REQUEST FOR INFORMATION DATE: April 11, 2016 NO.: RFI-028

Project Name: Webster University Interdisciplinary Science Building Project No.: 15051

Subject: BP 3 - pre-bid clarifications

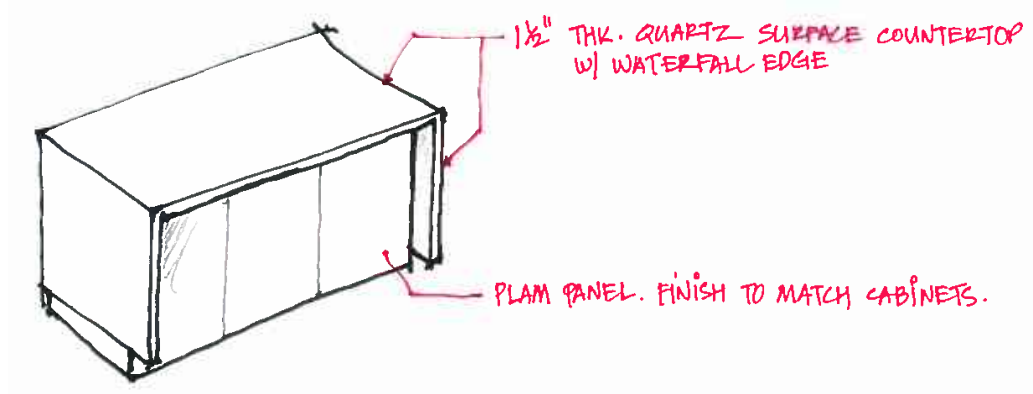
1. The kitchen island in Teaching Kitchen 174 does not have any section for detail cuts, please provide more detail.
2. Please confirm that the 1st and 2nd levels do NOT have wood jambs at the corridors, it appears these only occur on Levels 3 and 4.
3. Section cut 1/A0802 is called out on elevation 1/A0606, however drawing A0802 does not exist, please advise the correct section cut.
4. Time-Out Board is shown on 11/A0611 – what is a Time-Out Board? Who furnishes and installs it?
5. Section 114000 Food Service Equipment is confusing – equipment is listed on Pages 6-9, to the right of the Item some of the equipment is listed as N.I.C.; on the next line there are statements that the equipment is furnished and installed by the GC, Plumber or HVAC. Please revise and re-issue as a part of Bid Package No. 3

1. KITCHEN ISLAND HAS 1-1/2" THK. QUARTZ COUNTERTOP WITH WATERFALL EDGE. SEE SKETCH BELOW FOR FRONT OF THE ISLAND AND ELEVATION 2/A0607 FOR CASEWORK ON THE OTHER SIDE.
